Aeronautical Study No.
2017-WTE-2012-OE

**** NOTICE OF PRESUMED HAZARD ****

Structure:	Wind Turbine 1
Location:	Greenwood, NY
Latitude:	42-08-01.11N NAD 83
Longitude:	77-43-32.05W
Heights:	2258 feet site elevation (SE) 590 feet above ground level (AGL) 2848 feet above mean sea level (AMSL)

**** PUBLIC NOTICE ****

From Technical Operations:

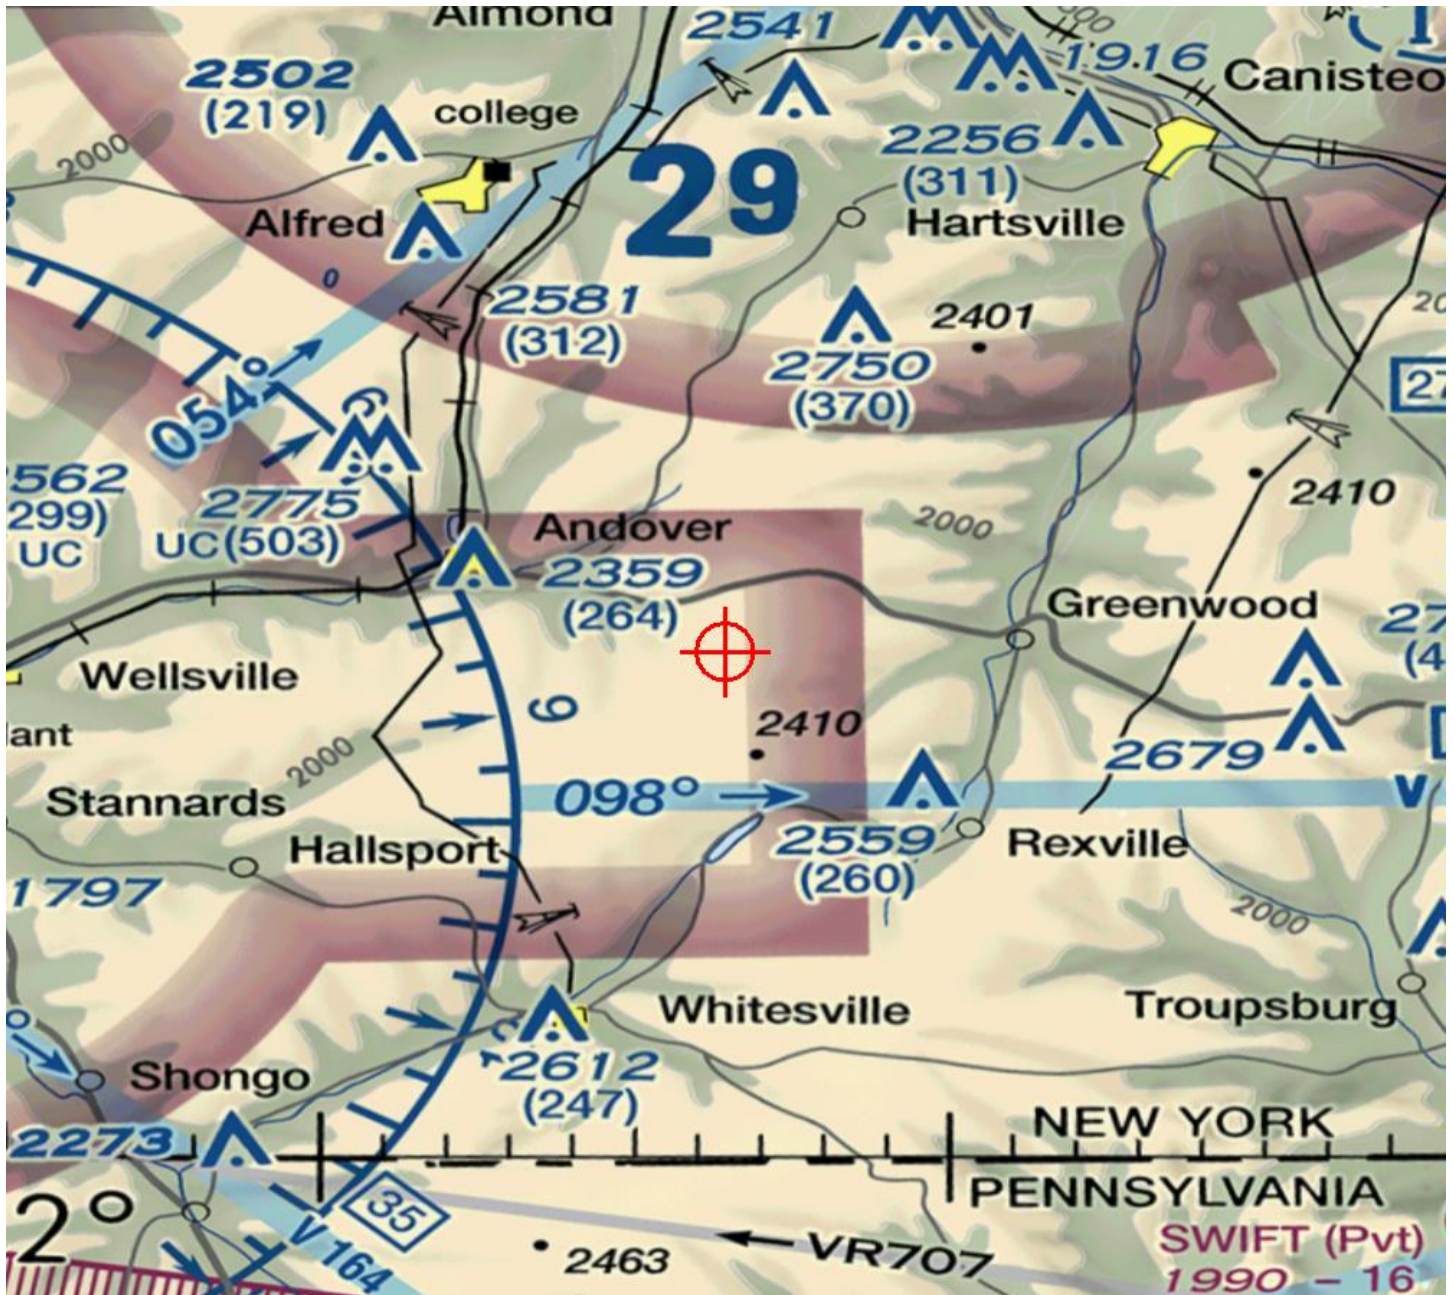
The proposal has a physical and / or electromagnetic radiation effect upon the Dansville, NY (DSV) Common Air Route Surveillance Radar (CARSR) facility(s). The proposal will affect the quality and/or availability of the DSV (CARSR) radar signal(s). Further study is necessary to fully determine the extent of the effect. The effects, their locations, and the facilities affected are: - Radar Facility: DSV (CARSR) Effects: 1) Unwanted primary-only returns (clutter) and primary-only target drops, all in the immediate area of the turbines. 2) Tracked primary-only targets could diverge from the aircraft path and follow wind turbines, when the aircraft is over or near the turbines. Facilities affected: Oberlin, OH (ZOB) Air Route Traffic Control Center (ARTCC) facility, Ronkonkoma, NY (ZNY) Air Route Traffic Control Center (ARTCC) facility, Rochester, NY (ROC) Terminal Radar Approach Control/ Air Traffic Control Tower (TRACON/ATCT) facility, Elmira, NY (ELM) Terminal Radar Approach Control/ Air Traffic Control Tower (TRACON/ATCT) facility, and Syracuse, NY (SYR) Terminal Radar Approach Control/ Air Traffic Control Tower (TRACON/ATCT) facility. This section requires further study, coordination and approval from air traffic operations.
